# Agenda Canmore Planning Commission Canmore Civic Centre – Council Chambers Wednesday, December 11, 2024, at 2:00 p.m.

Mixed-use building with ground floor Retail Sales (3 units) and second and third floor Visitor Accommodation (13 units total)

# **STAFF REPORT**

**APPLICATION NUMBER:** PL20240082

**DP-4.1**

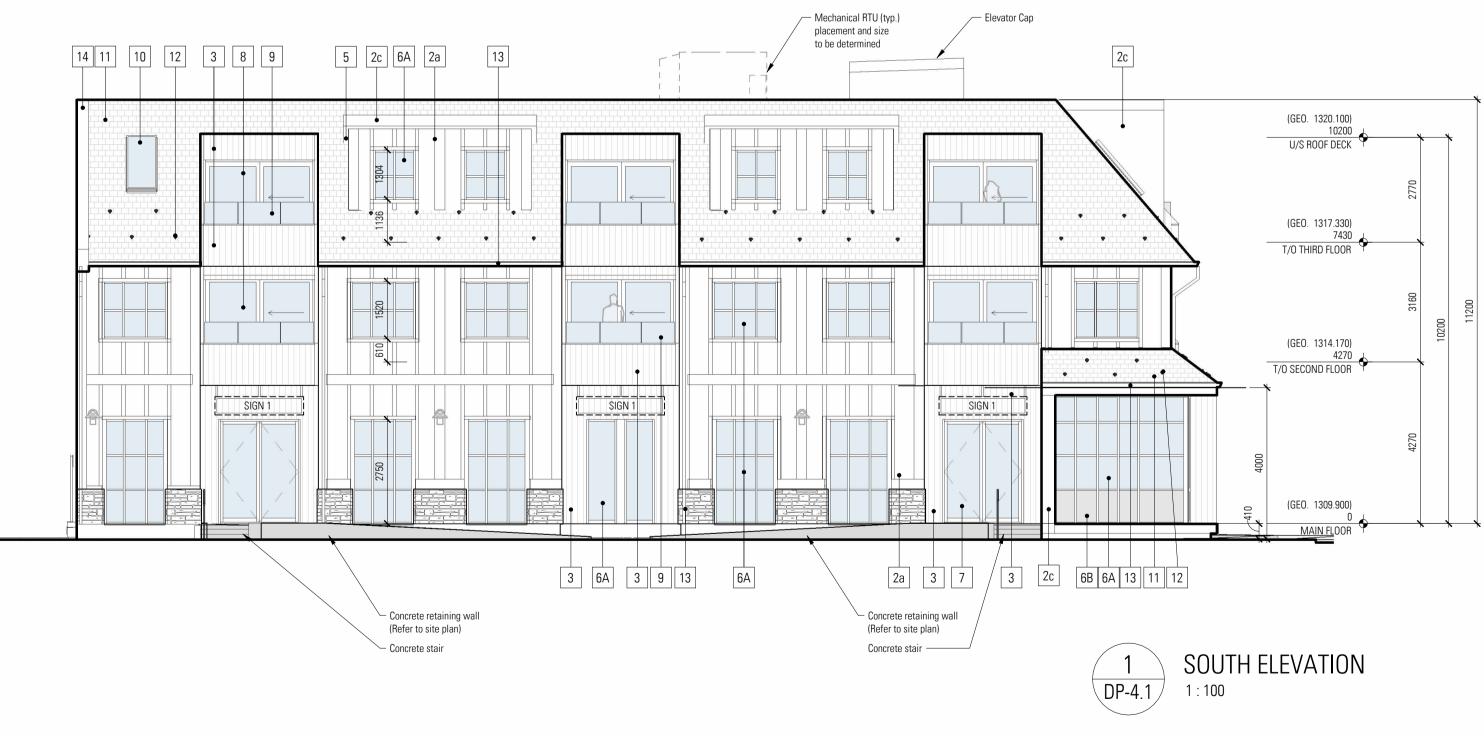
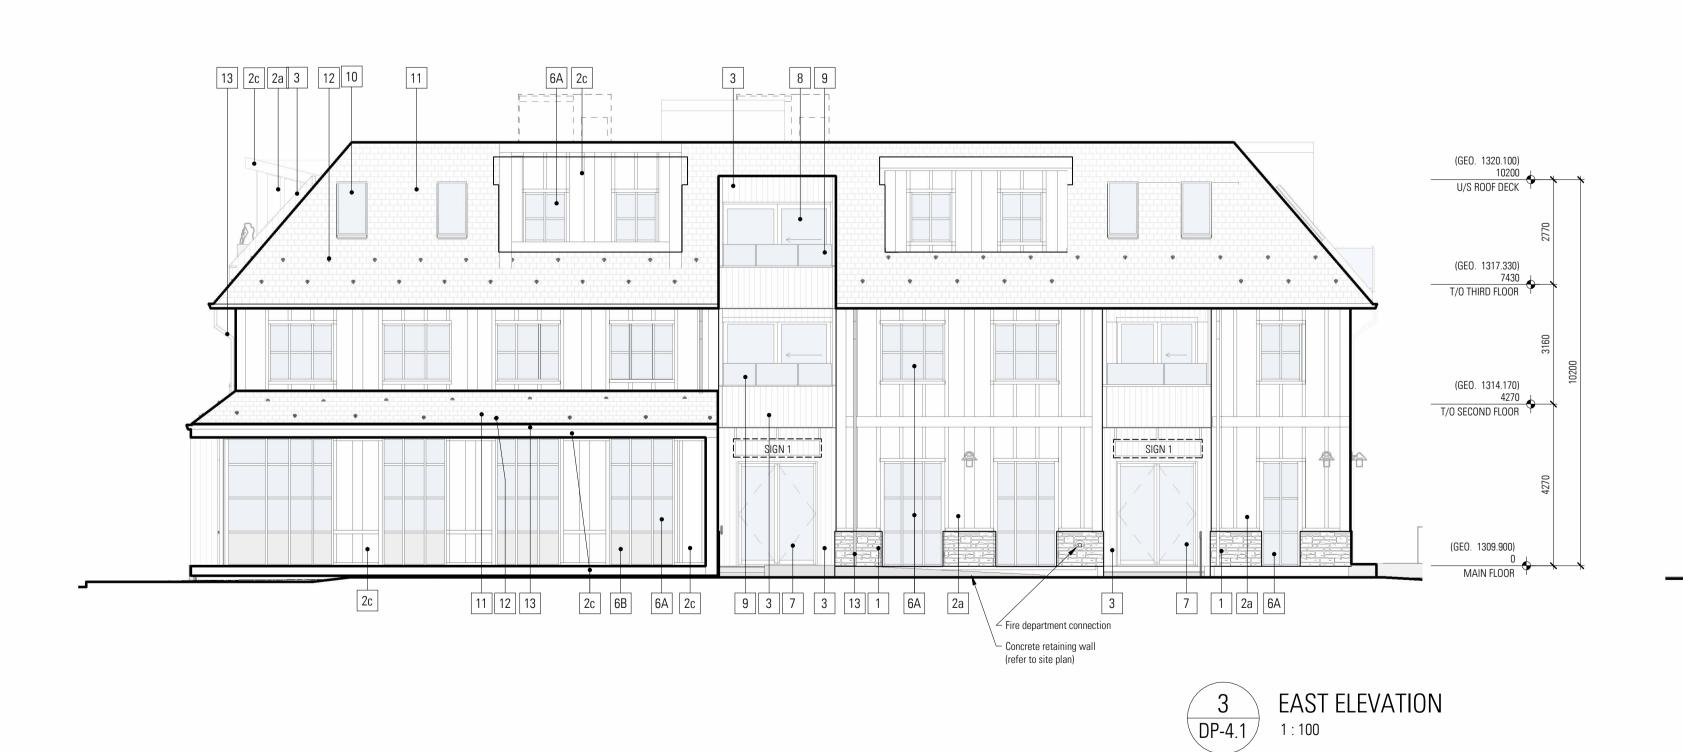
Section 4.1.3.8 of the LUB requires that the building's roof and eaveline height not exceed 11m and 7m, respectively. The proposed development includes a roof and eaveline height of 11.20m (1.8%) and 11.2m, respectively (See Attachment 4; Drawings DP-4). Therefore, a variance is required.

In Administration's opinion, the adjacent properties will not be unreasonably impacted with regards to access to light, views or privacy. The roof increase is small (approximately half a foot) and there is a firewall dividing the subject site and adjacent property. The increased eaveline height is limited to the rear of the building and the interior of the site, which in Administration's opinion, does not impact adjacent properties with regards to access to light, views or privacy. Note, the eaves along the frontages of the building comply with the requirements of the LUB. Considering this, Administration supports the roof and eaveline height variance.
